TB-164372 07 NOV 2022

Product:	Ghost
Product Description:	24/36v Ghost Trolling Motor (All Models)
Serial Range:	120784377 and below
Effective Date:	07 NOV 2022
Inspect/Update Current Inventory:	Yes

## Ghost Over Current Protection – Alternate Wire Routing

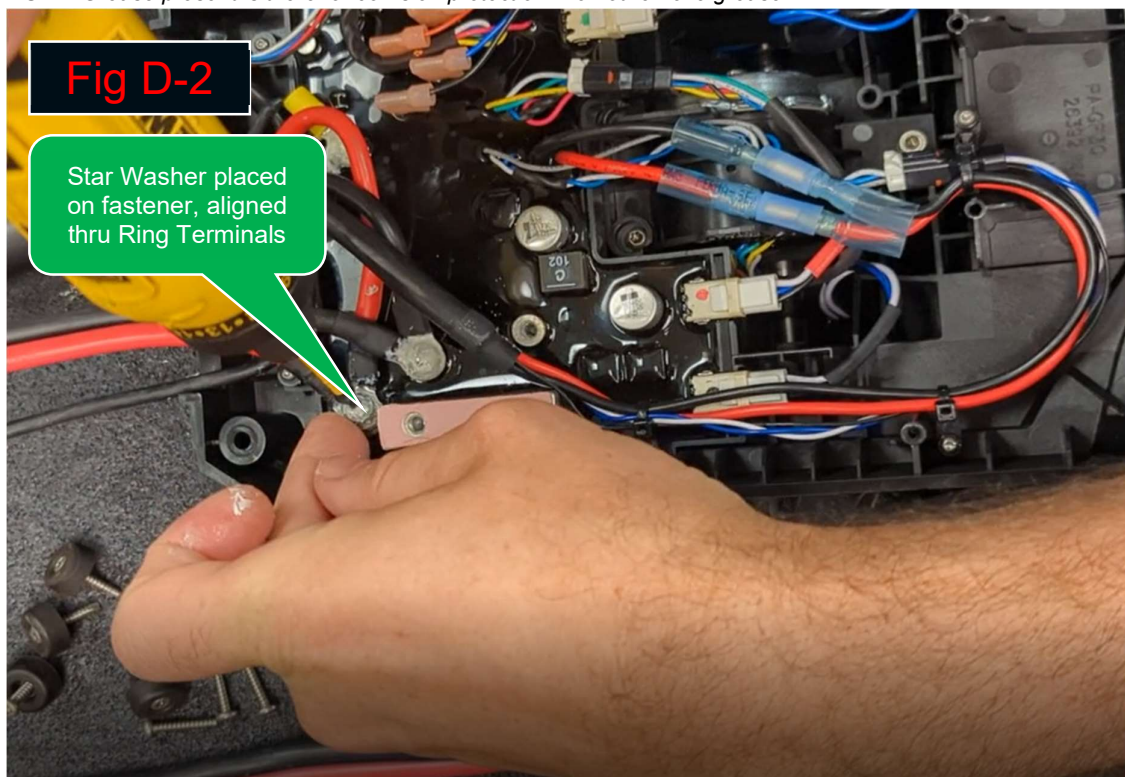
6. Once the fasteners are removed, Re-route Wire A (Solid Red Wire) from Location 4 to Location 1 with the Red+Black Wire per Fig D-1:

7. Re-apply the Star Washer to the fastener and align the Red+Red/Black wires and ring terminals to the Board Lug (Fig D-1)
  8. Apply blue threadlocker or super glue to the fastener thread before engagement to the board lug
  9. Re-Install the fastener through the ring terminals and into the board lug. (Fig D-2)
- NOTE:** Grease present is there for corrosion protection. Do not remove grease.
